ORDINARY MEETING OF COUNCIL SUPPLEMENTARY ITEMS

Tuesday 20 October 2020

17.1 10.2020.106.1 – Lot 317 DP 703905 – 68 Barton Drive, Kiama Downs - Demolition of laundry, garage and pool, alterations to garage and laundry and 2 Lot Subdivision

Figure 3 – Subdivision Plan

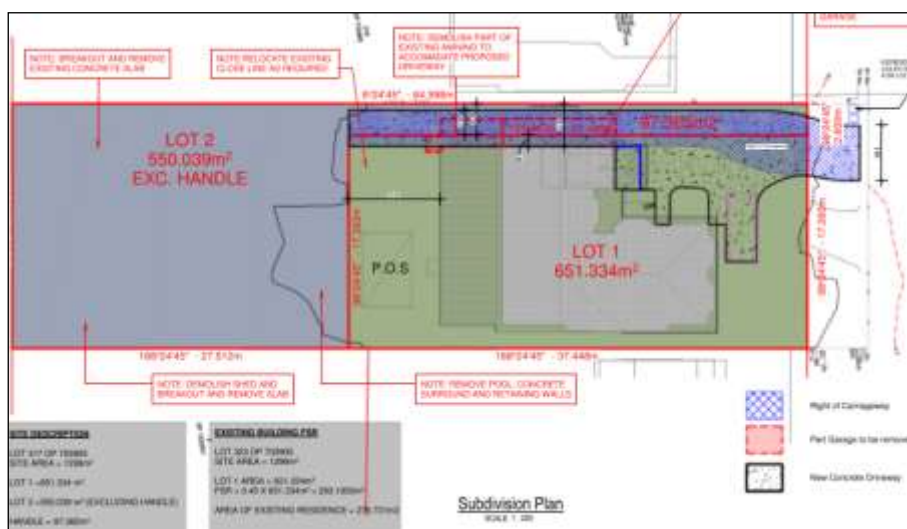
The proposed subdivision has an access corridor 3.5m comprising of a 3m wide carriageway and 0.5m wide landscaping strip adjacent to the western boundary. This does not comply with controls 5.1.17 and 5.1.18 of Kiama DCP 2020 as outlined below:

- **5.1.17** - *The minimum access corridor width for a battle axe allotment shall be 5m with a minimum carriageway width of 3m for the entire length of the access handle.*
- **5.1.18** - *A 1m wide landscaping strip shall be provided along each side of the required 3m wide road pavement. The landscaping strip shall be planted with suitable small trees, shrubs and groundcovers.*

- The proposed variation relates directly to the requirement to have a 1m wide landscaping strip either side of a 3m wide carriageway. The proposed carriageway maintains a compliant width of 3m to ensure safe and proper access to the proposed lot. Increasing the width of the landscaping strip would result in a non-compliant carriageway, adversely impacting upon access to the proposed lot.

- The ability for the proposal to comply with the relevant controls is severely impacted upon by the location of the existing dwelling house which is proposed to be retained (and reduced in size). The proposal seeks to demolish a portion of the existing garage to allow for access to the proposed lot at the rear. Further reducing the width of the existing garage to provide a compliant landscaping strip would result in an unusable garage that is not of sufficient size to accommodate a vehicle.

- It is considered that the provision of a compliant access way is more favourable than increasing the landscaping strip that would result in both the landscaping strip and the carriageway not complying with the relevant DCP controls.

- (4) The half-meter wide landscape strip shall be planted with suitable shrubs and groundcovers along the entire length of the driveway. The shrubs and groundcovers shall offer a variation in heights to form a significant softening of the hard surfaces. The ground shall be covered with 75mm minimum organic mulch.
